## UNITED STATES PATENT AND TRADEMARK OFFICE

# Office Action Summary

Application No.	Applicant(s)	
10/565,198	SHIMIZU ET AL.	
Examiner	Art Unit	
MARLON A. ARCE DIAZ	3611

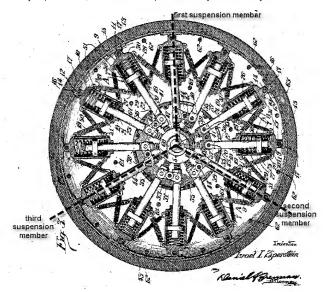
- 4. Claim 1 is rejected under 35 U.S.C. 103(a) as being unpatentable over Cabrera (US 5868413) in view of Ziperstein (US 1579589). Cabrera discloses a unicycle with handle comprising: a wheel (21) a rim (17), an axle (20) at the center of the rim, a connecting piece (18,19) connecting the axle to the rim, a pedal (22,23) driving the axle, a frame portion (fig 2 and 3) connected to the axle on one end and connected to the handle and saddle portions on the other end; said handle and the saddle portions are arranged at an angle from each other {{almost a 90° angle between the handle tube 34 and the seat 32 of the saddle portion}}. Cabrera fails to mention the suspension members arranged in intervals of 120 degrees. However; Ziperstein discloses a wheel comprising: a plurality of suspension members arranged in different angles (fig 3); a

couple of said suspension members when view separately have an arrangement with intervals of 120 degrees (see figure below, specifically the doted lines). It would have been obvious for someone skilled in the art to add the wheel with suspension members into the monocycle disclosed by Cabrera, in order to be able to make the riding of the monocycle pleasurable, and in order to help the ride ability of the monocycle.
